ADDENDUM THREE

CITY OF PHARR

PHARR NEW AQUATIC CENTER

March 28, 2012

DRAWN:	LEDUCCAD
CHECKED:	H.LEDUC
JOB NO.	1160
DATE:	03/21/12
DRAWING NO.	E103

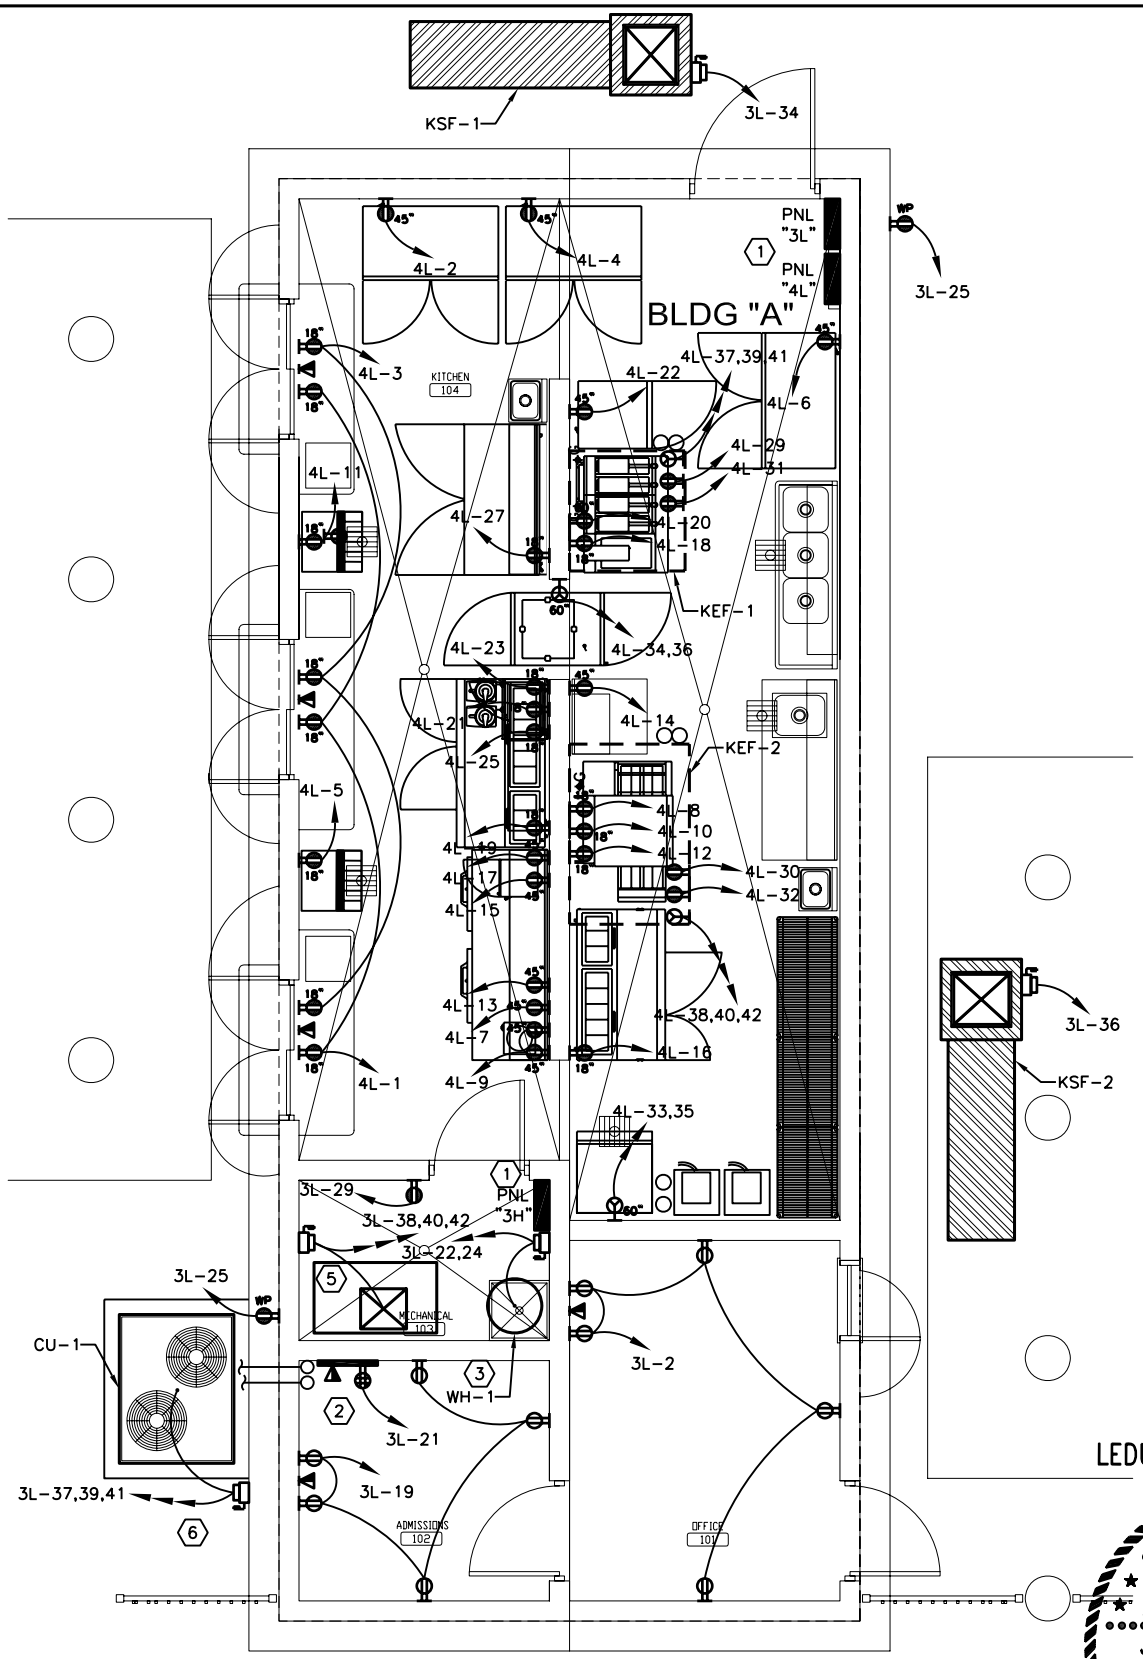
1. Changed AHU-1 and CU-1 on building "A" from a 5 Ton unit to a 7.5 Ton unit. Sheet M101
2. Redistribute CFM to supply grills on building "A" sheet M101.
3. Added two Captive Air kitchen supply fans to kitchen hoods.
4. Specify new AHU-1 and CU-1 on equipment schedules sheet M103.
5. Specify new KEFs and KSFs on fan schedule sheet M103.
6. Modify the electrical circuits for the AHU-1 and CU-1 sheet E103.
7. Added the electrical circuits for both KSFs sheet E103.
8. Modify electrical panel '3L' to new AHU-1, CU-1, and KSFs sheet E106.
9. Modify electrical riser with new disconnect and conduit size for AHU-1 and CU-1 sheet E108.
10. Clarification of plumbing fixture schedule sheet P104.
